Alpine Mountain Ranch Lot 30

Building Envelope Removal

ACTIVITY #: PL20230094
DECISION DATE: 11/29/2023
PETITIONER: Irvine, David & Ethel
PETITION: Subdivision - LPS Amendment; a re-plat of AMR Lot 30 to remove building envelope and create no-build zones
LEGAL DESCRIPTION: LOT 30, ALPINE MOUNTAIN RANCH LPSE, 5.00 A
LOCATION: 34510 GOLDEN EAGLE DRIVE
Approximately .83 miles ESE of the intersection of Meadow Creek Drive & US HWY 40
ZONE DISTRICT: Agriculture & Forestry (A/F)
AREA: 5.00
STAFF CONTACT: Blake Kelly; bkelly@co.routt.co.us
ATTACHMENTS:

SLOPE ANALYSIS

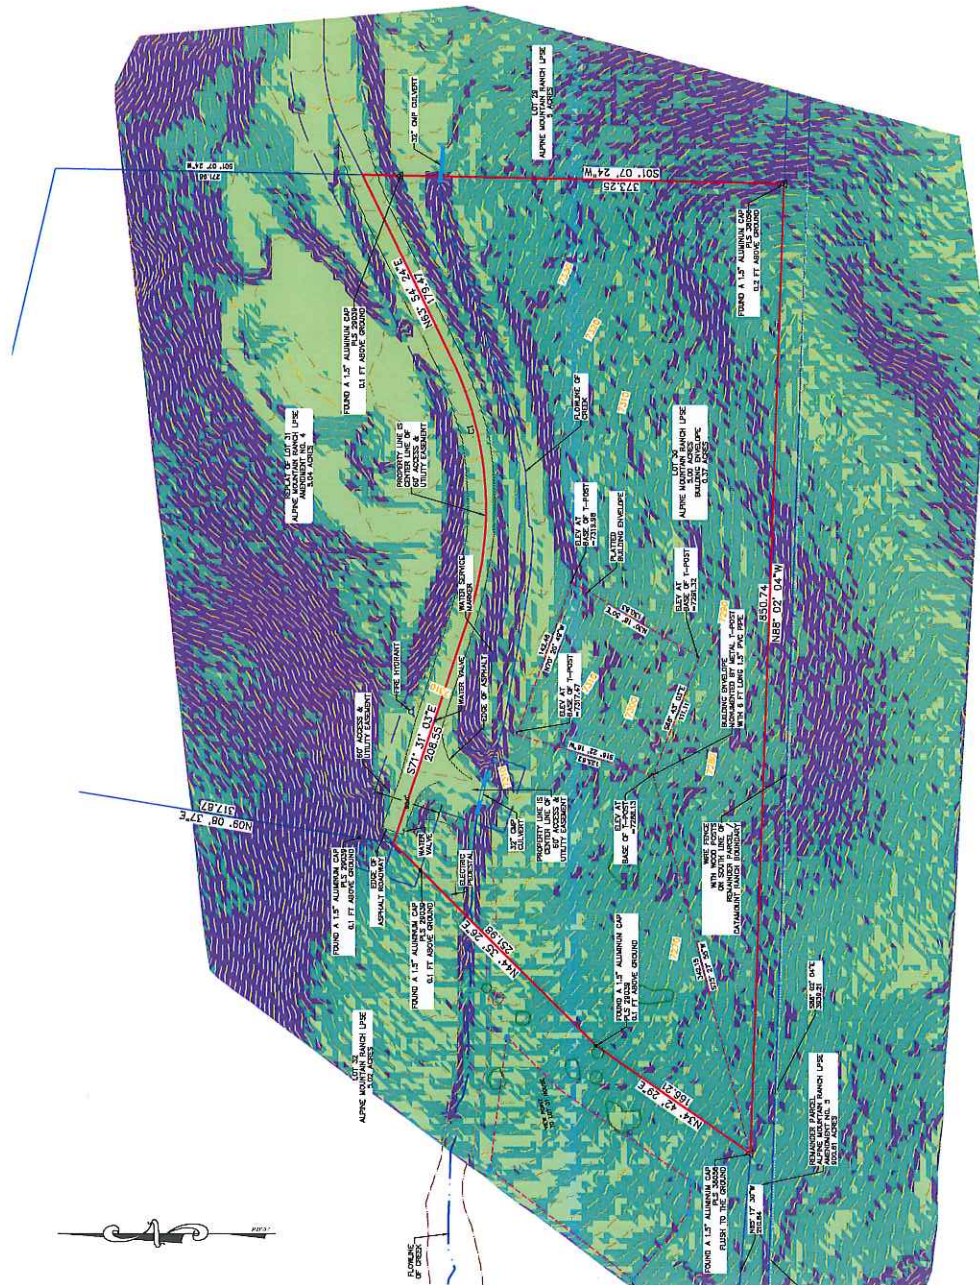
- The only constraints that are present on this site are steep slopes in the southern portion of the lot.
- CPW provided no comments related to this proposal.

Staff comments: The entire lot is mapped to have potentially unstable slopes. A small portion of the northwest corner of the lot is mapped to be high fire hazard; the remainder of the lot is mapped to have no fire hazard. Since these lots exist, the removal of the building envelopes will not increase the impact.

1. The plat shall be finalized and recorded within one (1) year unless such time is otherwise extended pursuant to Section 2.1.6, Routt County Subdivision Regulations. Extensions to up to one (1) year may be approved administratively.
2. Prior to recordation, the applicant shall submit an electronic copy of the approved plat to the County Planning Department in a .DWG format or other format acceptable to the GIS Department.
3. All property taxes must be paid prior to the recording of the plat.
4. All conditions of the Alpine Mountain Ranch LPS approval and requirements of the Development Agreement shall continue to apply.
5. The plat shall reflect the "No Build" zones for slopes over 30% as submitted in the slope analysis report.
